AS- BUILT PLANS

WATER DISTRIBUTION SYSTEM

STONEY POINTE 6TH ADD.

CITY OF WICHITA, KANSAS

LINES 1 & 2

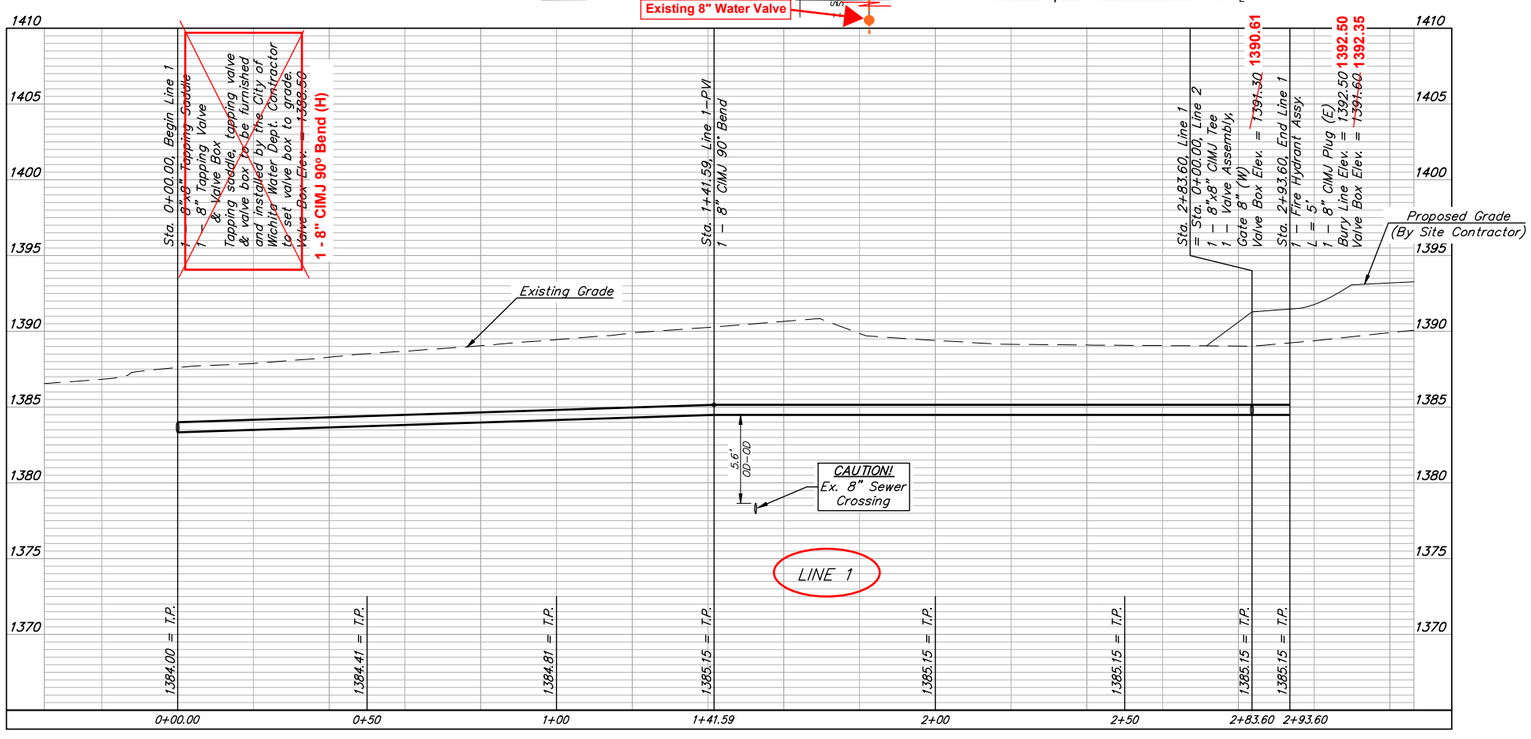
NOTE:
Sta. 0+00:
Installed 90° Bend (H).
Existing 2" Blow-Off Valve was Removed.
Existing Water Main Pipe was cut 4' +/- to get to Sta 0+00 for new 90° Bend (H).

Sta. 0+39.24, End Line 2
1 – Valve Assembly, Blowoff 2"
Valve Box Elev. = ~~1388.20~~
N=388,455.66 E=17,585,876.29

~~39.24~~ L.F. 8" Pipe
40.4'

~~142.01~~ L.F. 8" Pipe
141.2'

~~141.59~~ L.F. 8" Pipe
140.5

Sta. 2+93.60, End Line 1
1 – Fire Hydrant Assy.
L = 5' Facing South
1 – 8" CIMJ Plug (E)
Bury Line Elev. = ~~1392.50~~
Valve Box Elev. = ~~1391.60~~
~~N=388,455.72 E=17,585,925.53~~

~~10.00~~ L.F. 8" DICL Pipe
8.9'

Sta. 2+83.60, Line 1
= Sta. 0+00.00, Line 2
1 – 8"x8" CIMJ Tee
1 – Valve Assembly, Gate 8" (W)
Valve Box Elev. = ~~1391.30~~
~~N=388,455.71 E=17,585,915.53~~

Sta. 1+41.59, Line 1
1 – 8" CIMJ 90° Bend
~~N=388,313.70 E=17,585,915.71~~
